RE: M-Keds Plat 1 Lot 2 Site Plan

The Development Services Department is in receipt of a proposed Site Plan for M-Keds Plat 1 Lot 2. Based on the review of the provided submittal materials, staff have the following comments:

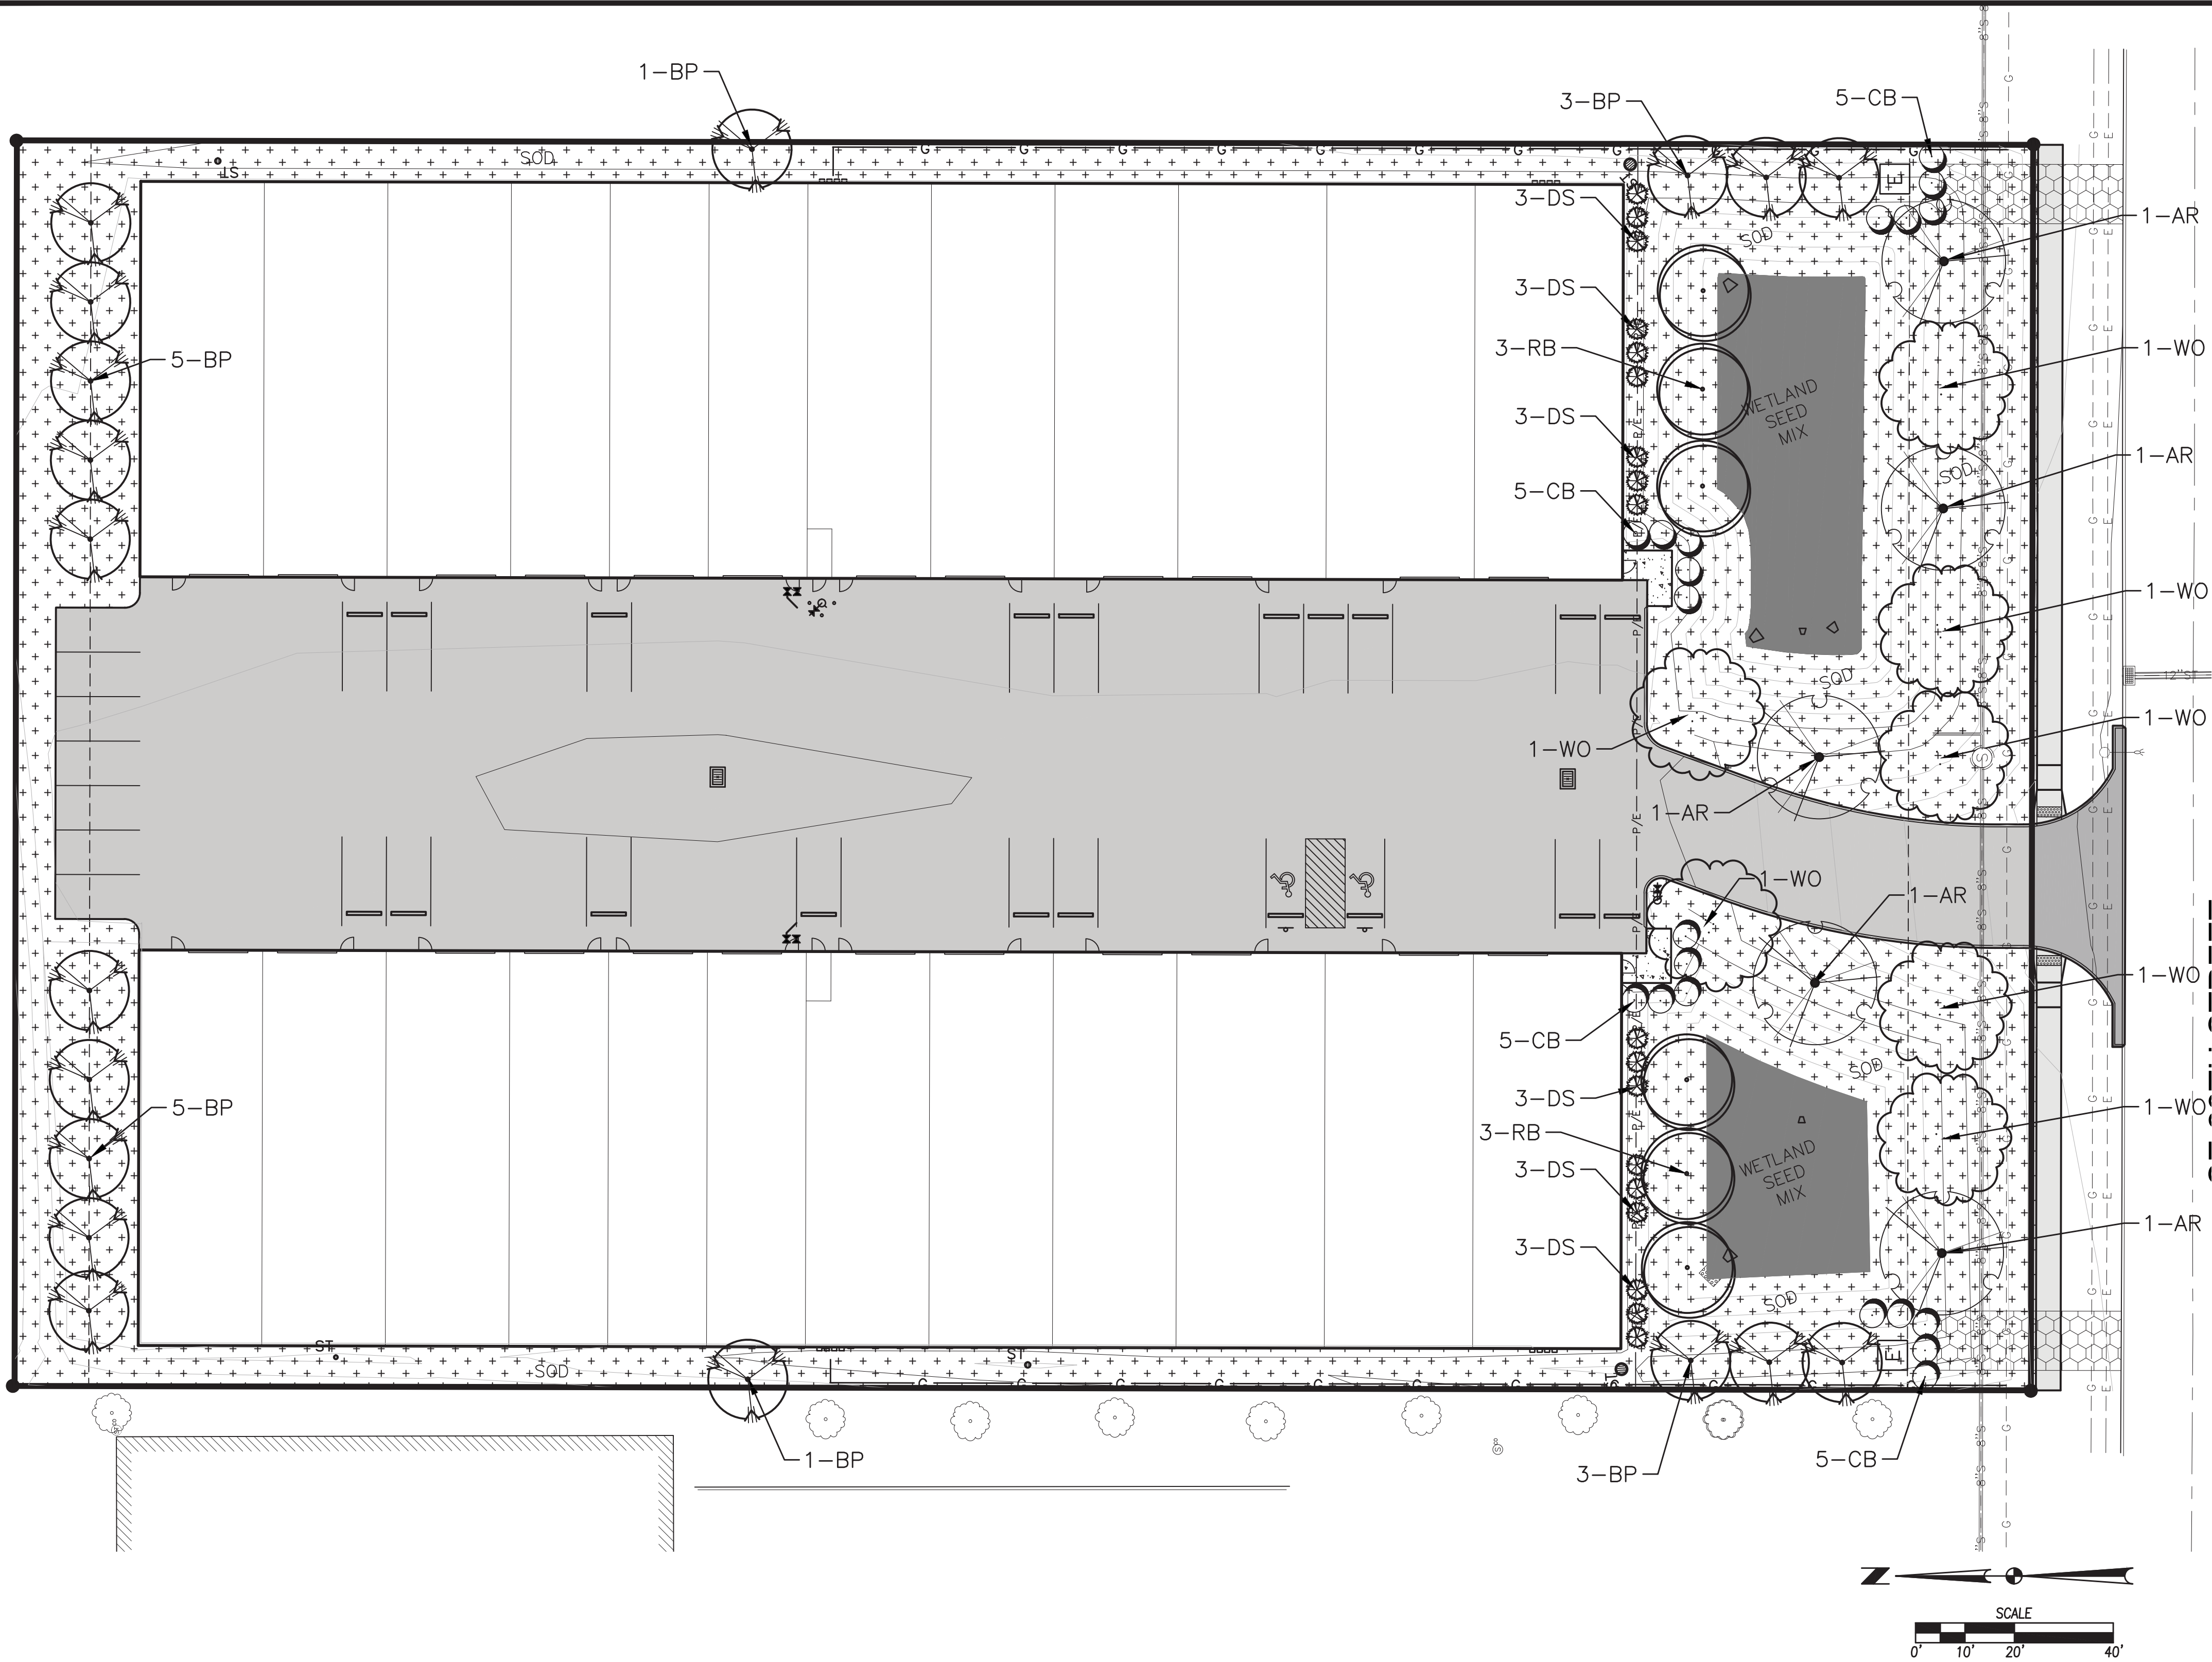
- ~~1. 32 trees and 31 shrubs are required (2 trees/1000sf open space & 1 shrub/500 sf open space). You are correct 31 trees and 31 shrubs are required. The minimum requirement will have to be met.~~

2. ~~A minimum of 1 tree/50' of frontage on 28th Street shall be planted.~~
3. ~~Landscaping is required along the building frontage facing SE 28th Street.~~
4. ~~Add the type of ground cover to the plant schedule. Please revise to SOD.~~
5. ~~Staff would suggest revising the tree species for those that are located in the detention basin side slope. Alternatively, the trees may be shifted south to the top of the berm. Please ensure there is at least 8 feet from the sanitary sewer main.~~
